RN SERIES TECHNICAL BULLETIN

ISSUE NO. : RNT-014

SUBJECT: 021-19055-205 Bracket; Safety SW Ass'y

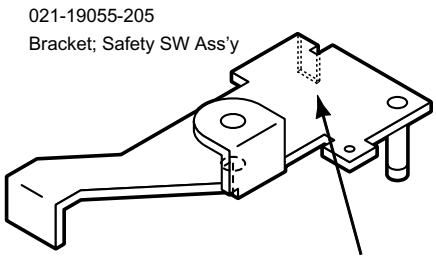
This bent-down portion of the metal sheet is extended 4.5 millimeters.
Old part number 021-19055-108 was 15 mm in length.
The new part number 021-19055-205 is 19.5 mm in length.

Modification:
The bent portion of the part, to act as a stopper against "Bottom Bracket; M.-Disposal Gate Housing", is made longer, from 15 millimeters on the old part to 19.5 millimeters on the new part. An extension of 4.5 millimeters.

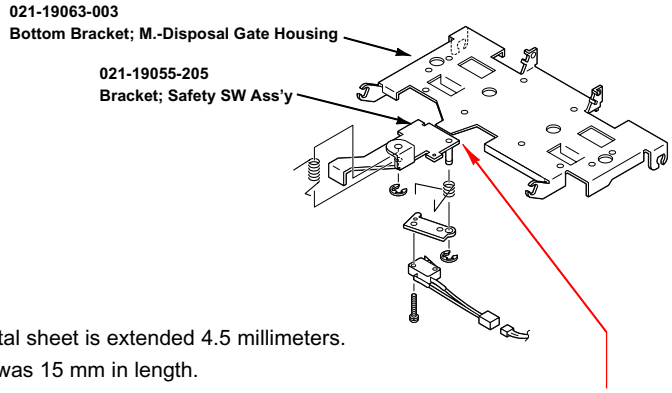
"Bracket; Safety SW Ass'y" had a possibility of riding on top of the "Bottom Bracket; M.-Disposal Gate Housing".
